Access Compliance Report

Public Rights-of-Way

(Curb Ramps)

Intersection ID: 11832	Main Street: DICKENS_AV	Cross Street: DUBLIN_RD	Location:	N
ADA ID: 1EDD6461422C	Ramp Type: Perp	Initial Pass/Fail: Fail	Overall Compliance: No	Severity Score: 10

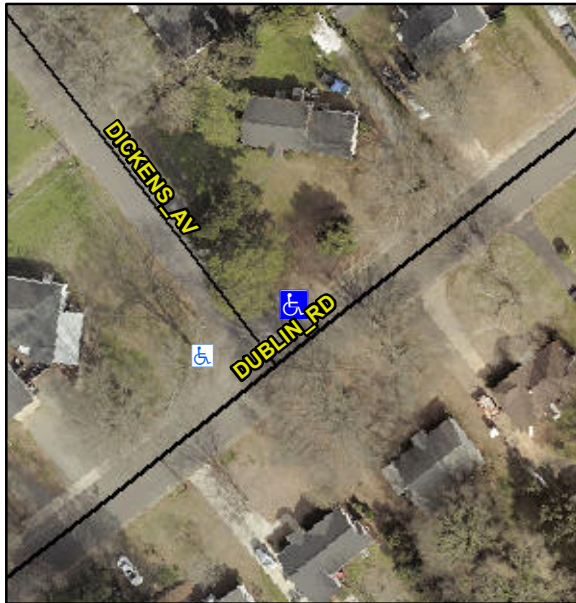
Not Found, R304.5.1, R304.5.3

Compliance	Description	Data	Compliance	Description	Data
N/A	Ramp Length (in)	47.0	Yes	Ramp Slope (%)	5.5
No	Ramp Width (in)	40.5	No	Ramp XSlope (%)	4.1
N/A	Flare Type LT	N/A	N/A	Flare Type RT	N/A
N/A	Flare Slope LT (%)	N/A	N/A	Flare Slope RT (%)	N/A
N/A	Flare Traversable LT?	N/A	N/A	Flare Traversable RT?	N/A
N/A	Landing Length (in)	N/A	N/A	DWS Provided?	N/A
N/A	Landing Width (in)	N/A	N/A	DWS Contrast?	N/A
N/A	Landing Slope (%)	N/A	N/A	DWS Length (in)	N/A
N/A	Landing X Slope (%)	N/A	N/A	DWS Full Width?	N/A
N/A	Landing Curb? (Y/N)	N/A	N/A	DWS Offset (in)	N/A
N/A	Shared Landing?	N/A			
N/A	Gutter Ponding?	N/A	N/A	Gutter Slope (%)	N/A
N/A	Gutter Lip Ht (in)	N/A	N/A	Gutter X Slope (%)	N/A
N/A	Painted X Walk1?	No	N/A	Painted X Walk2?	N/A
	X Walk 1 Direction	To SW		X Walk 2 Direction	N/A
N/A	X Walk 1 Width (in)	N/A	N/A	X Walk 2 Width (in)	N/A
	X Walk 1 Slope (%)	4.4		X Walk 2 Slope (%)	N/A
	X Walk 1 X Slope (%)	1.1		X Walk 2 X Slope (%)	N/A

Remove & Replace Entire Ramp.
